East El Paso Regional Park

City of El Paso — City Plan Commission — July 12, 2018

SUSU18-00016 — Major Preliminary

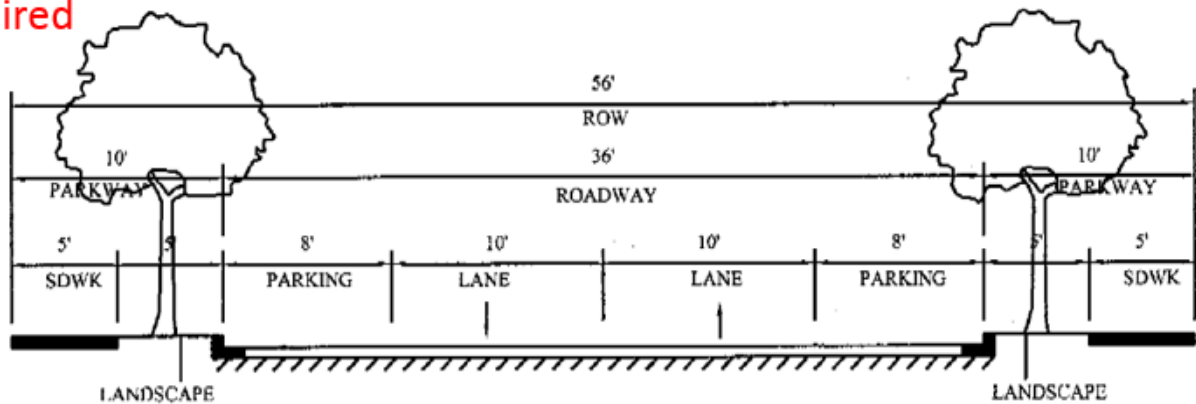
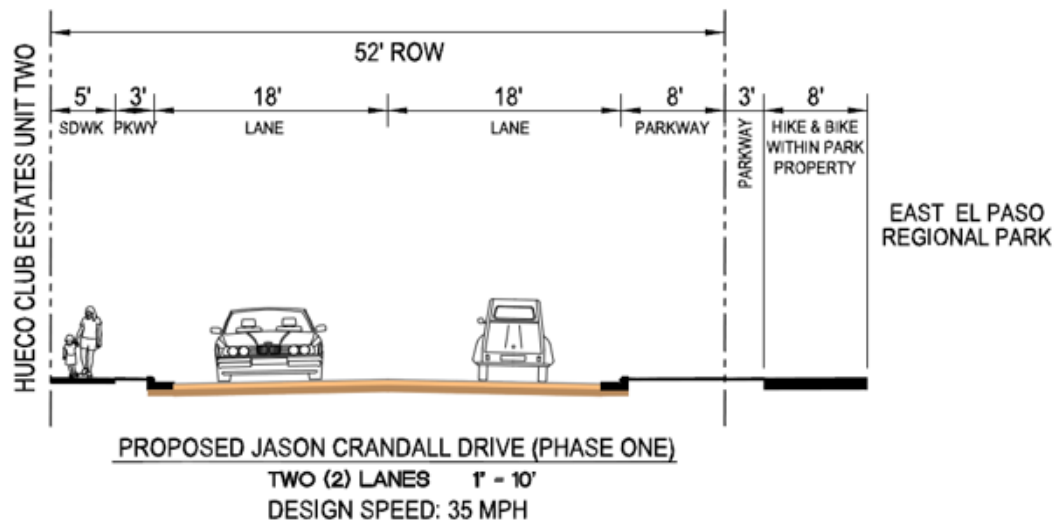
The applicant is requesting the following exception under 19.10.050-A (Roadway participation policies):

- To waive 2' of ROW dedication and 5' sidewalk for Jason Crandall Drive.

Instead, the applicant will be constructing a 3' parkway and an 8' hike and bike within the park property.

ATTACHMENT 2

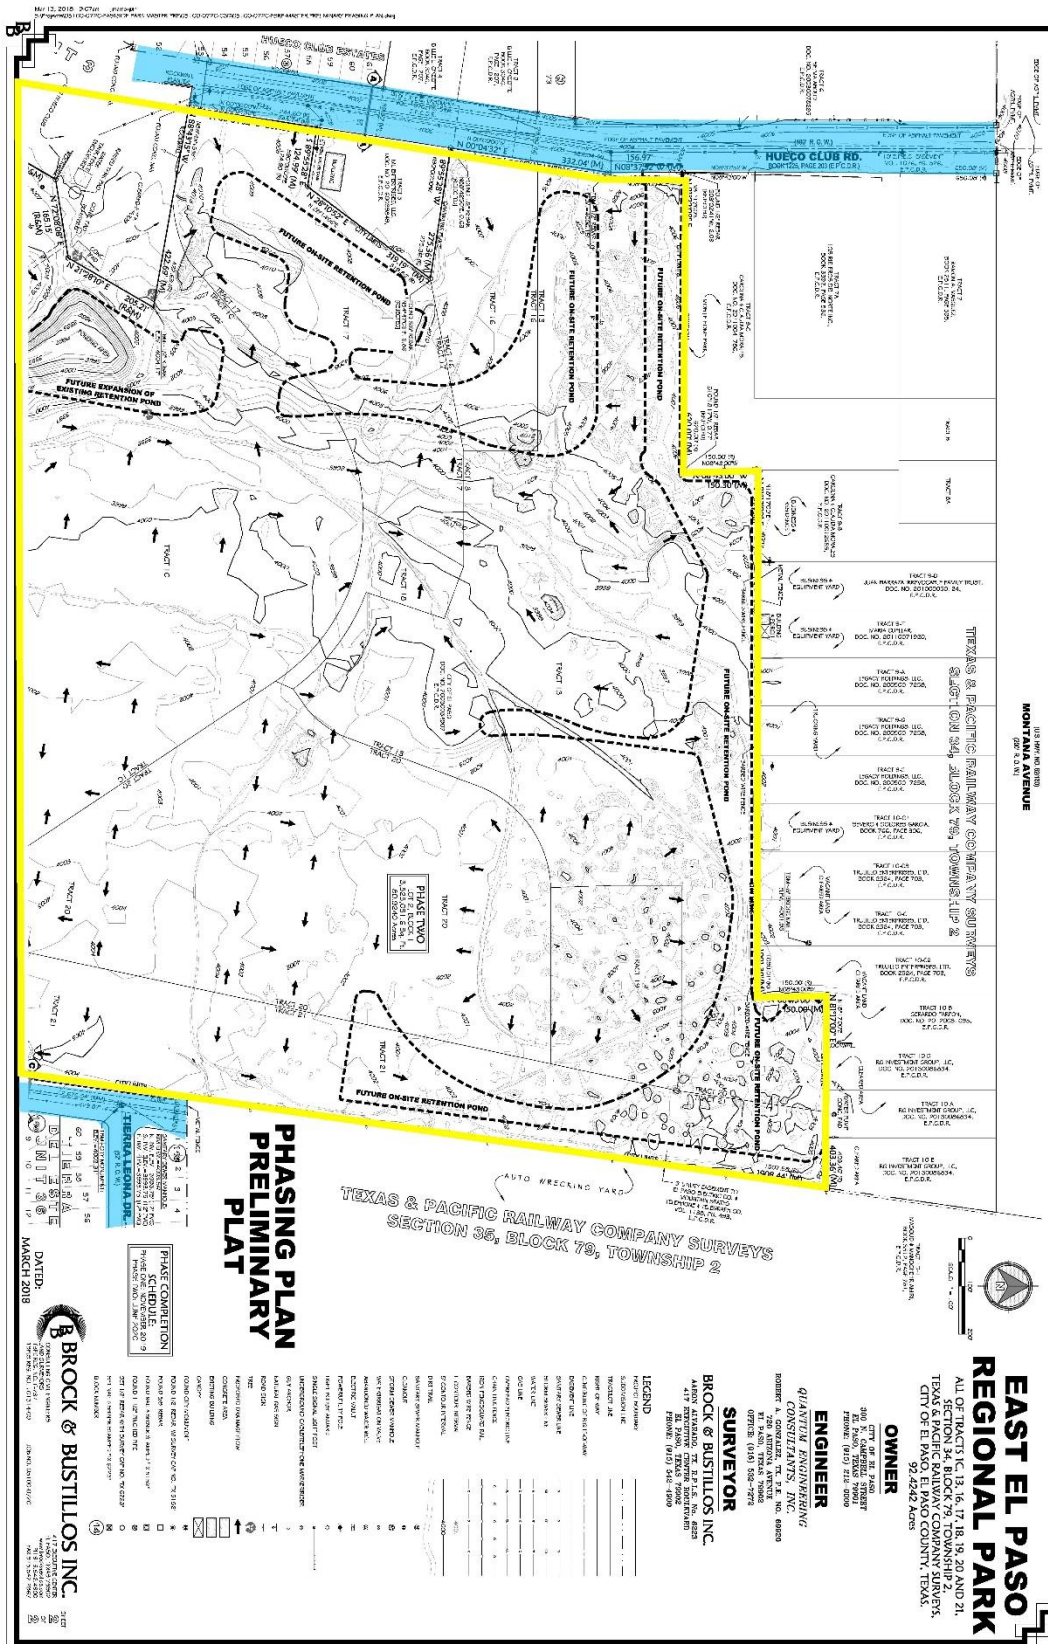
The entire right-of-way for the extension of Tierra Dorado should be dedicated within the Eastside Regional Park Subdivision. The City does not need to improve the entire ROW but maybe only half and defer improvements on the other half until later.

Applicant is to coordinate with EPWater the alignment and width of the proposed PSB easement.

The 25-foot PSB easements shall be shown along the entire length of the plat for the extension of the future public mains.
